## Report to the Planning and Zoning Commission

<b>Case:</b>	S2020008 –Trethan Farms
<b>Hearing Date:</b>	July 23, 2020
<b>Supervisor District:</b>	4
<hr/>	
<b>Applicant:</b>	Adam Baugh, Withey Morris, PLC
<b>Owner:</b>	Jewel Investments Company, LLC
<b>Request:</b>	Preliminary plat for 76 lots and 3 tracts in the R1-6 RUPD zoning district
<b>Site Location:</b>	Generally located at the southwest corner of Olive Avenue & Cotton Lane, in the Glendale area
<b>Site Size:</b>	Approx. 18.7 acres
<b>Density:</b>	4.06 d.u./ac.
<b>County Island:</b>	No
<b>County Plans:</b>	1. White Tank / Grand Avenue Area Plan - Rural (0-1 d.u./ac.) 2. Olive Avenue Scenic Corridor
<b>Municipal Plan:</b>	Glendale – MDR 3.5 – Medium Density Residential (2.5-3.5 d.u./ac.)
<b>Municipal Comments:</b>	None received to date
<b>Support/Opposition:</b>	None known
<b>Recommendation:</b>	<b>Approve</b> with conditions

Proposed Preliminary Plat  
(North is to the Right)

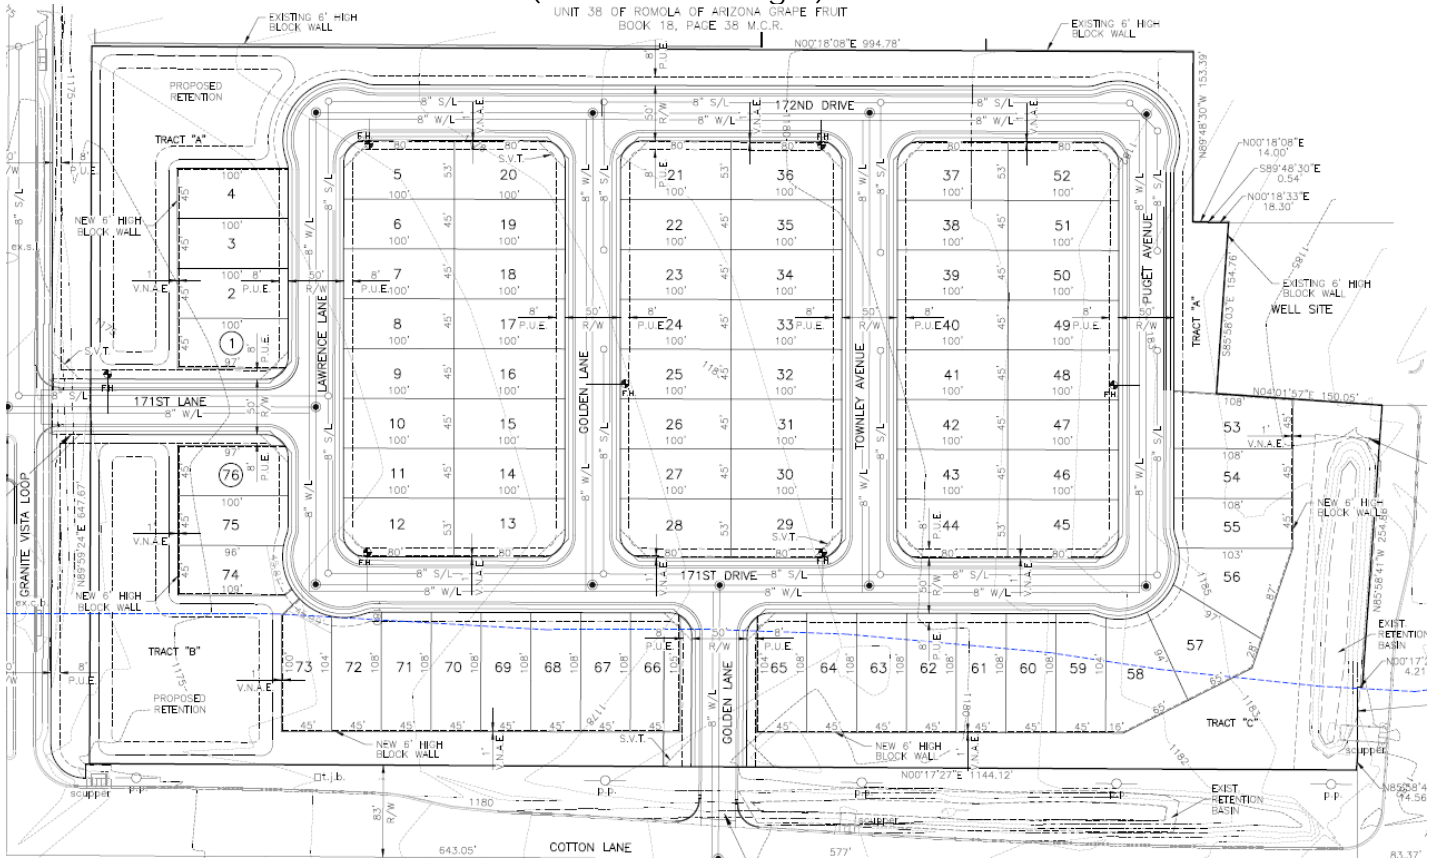
- 2. The FIRM Index date on the Floodplain Table should be updated to 11/04/2015.
  - 3. The Letter of Map Revision (LOMR) must be approved by the Flood Control District of Maricopa County prior to Final Plat approval.

- 7. Based on the conceptual design nature of the information submitted, changes to the site layout and/or a reduction in the number of building lots may be necessitated by the final engineering design of the subdivision drainage infrastructure.

- j. Specific roadway cross-sections and pavement sections are not approved as shown on the Preliminary Plat. The number and width of lanes, including turn and auxiliary lanes, as well as pavement thickness, will be approved on construction improvement plans in conjunction with the Final Plat, in compliance with the Traffic Impact Statement (TIS) approved by the Maricopa County Department of Transportation (MCDOT).
